Application by Tritax Symmetry (Hinckley) Limited for an Order Granting Development Consent for the Hinckley National Rail Freight Interchange – Deadline 4 submission

Deadline 4 response

Response to questions posed by the Examining Authority

Figure 1.1: Location of 'local' traffic counts to the Hinckley NRFI

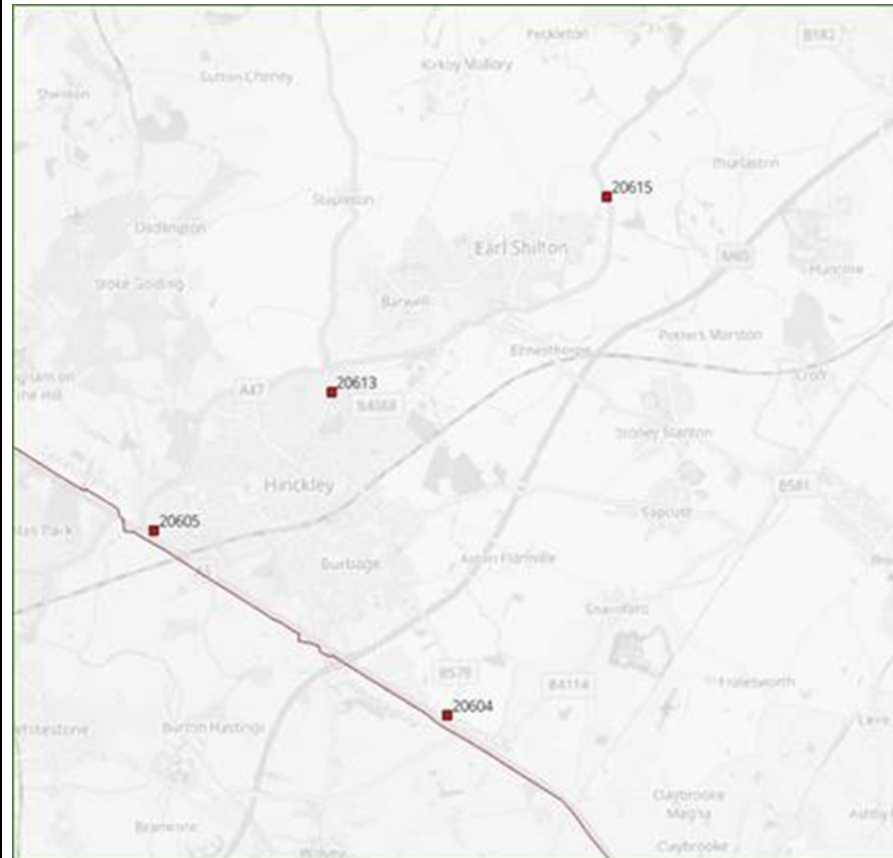
The counts used to inform the 'local' review of traffic conditions are shown below in Figure 1.1:

By vehicle type the percentage differences between March 2019 and 2023 are shown below in Table 1.1 below. The peak hours are highlighted to enable comparison to the Applicant's figures.

The ExA will note that based on ATC held by LCC, that the figures above do not align with those presented by the Applicant. Indeed, they demonstrate that traffic has not reduced to the extent suggested. In short, the Applicant states a reduction of 5.8% in the AM peak, LCC local data confirms the contrary i.e. a 3.9% increase. In the PM peak, the Applicant states a 8.1% reduction, LCC local data confirms a much smaller 1.4% reduction.
